CITY OF FORT LAUDERDALE

CASE COMMENT REPORT

CASE NO. UDP-S25041

CASE	UDP-S25041
PROJECT NAME	Sistrunk View
APPLICATION TYPE	Site Plan Level III
APPROVAL LEVEL	Planning and Zoning Board, Subject to 30-Day Commission Request for Review
REQUEST	Conditional Use for a Mixed-Use Development with 100 Affordable Housing Units and 5,500 Square Feet of Commercial Use with an Associated Parking Reduction
APPLICANT	Fort Lauderdale Community Redevelopment Agency
AGENT	Greg Brewton, GBA
PROPERTY ADDRESS	790 NW 6 Street
ABBREVIATED LEGAL DESCRIPTION	North Lauderdale 1-48 D Lots 3,6-8, and 45-51 Blk 15
ZONING DISTRICT	Northwest Regional Activity Center – Mixed Use West (NWRAC-MUw) and Residential Multifamily Mid Rise/Medium High Density (RMM-25) District
LAND USE	Northwest Regional Activity Center (NWRAC)
COMMISSION DISTRICT	3 – Pamela Beasley-Pittman
NEIGHBORHOOD ASSOCIATION	Historical Dorsey-Riverbend Civic Association, Inc.
SUBMITTED	October 9, 2025
COMPLETENESS ISSUED	November 14, 2025

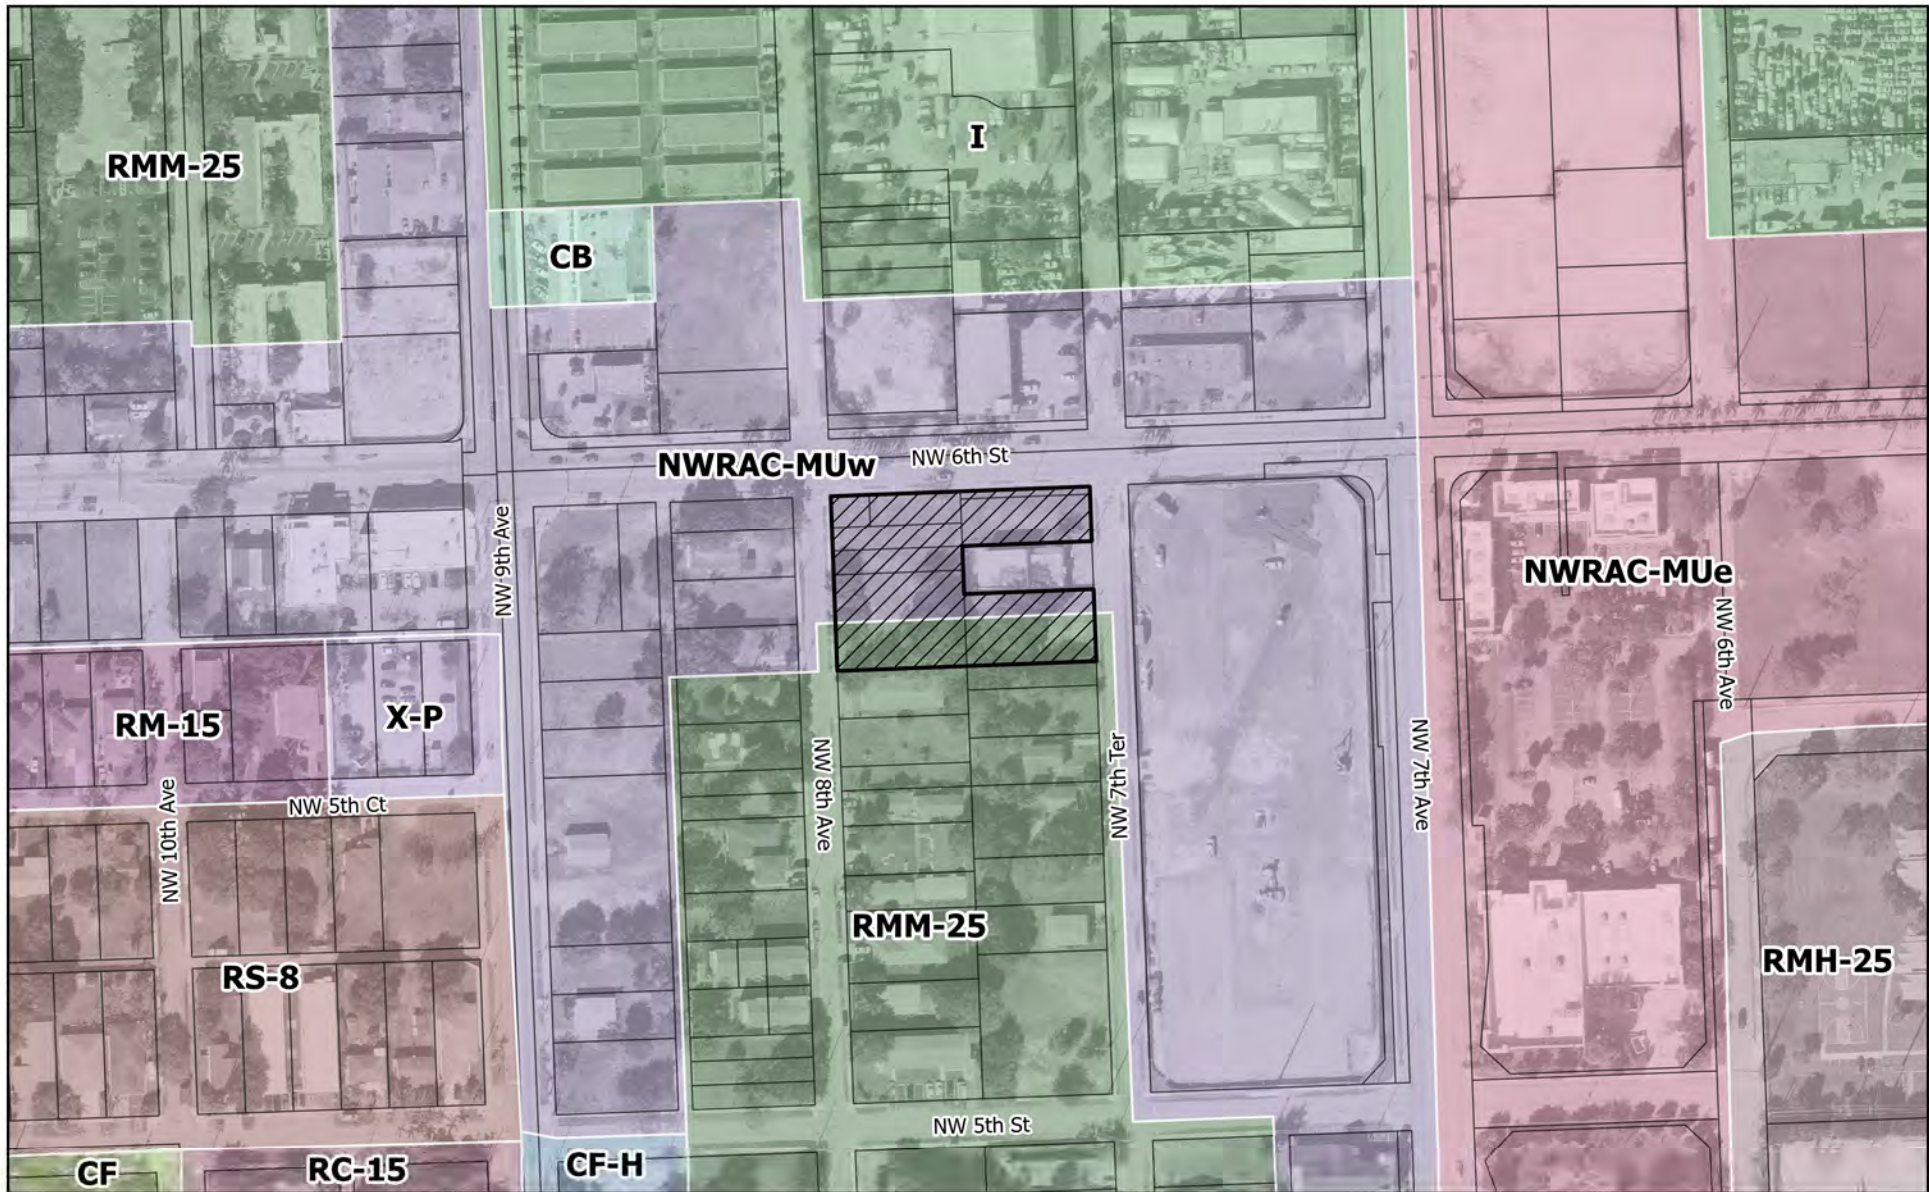
- b. Emphasize the east and west corners of the building along Sistrunk Blvd. Provide architectural elements or banding that accentuates the building entrances and the corners. See images below:

- c. Bring the height of the rooftop element down, as it adds to the buildings massiveness, and does not enhance the quality or drama of the building roofline.
